Building Code of Australia

Assessment Report

**Project Address: Telopea Stage 1A, Lot 5-7 Sturt
Street, Telopea**

Revision: R06

| Clause | Performance justification |
|------------------------------------|--|
| |  <p>Example of public corridor exceeding 40m</p> |

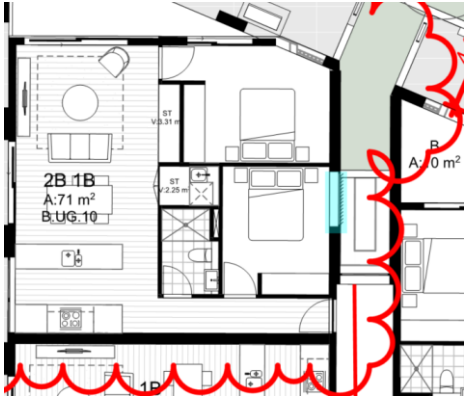
| Clause | Performance justification |
|--|---|
| C3D15 Public corridors in Class 2 and 3 Buildings | <p>The following public corridors exceed 40m without smoke proof walls:</p> <p>Tower B</p> <ul style="list-style-type: none"> Upper ground floor Approx. 53 L2 Approx. 48.2m. <p>Tower D</p> <ul style="list-style-type: none"> Upper ground floor Approx. 46m. <p>Tower E</p> <ul style="list-style-type: none"> Upper ground floor Approx. 57m L1 – L8 Approx. 51.4m.. |
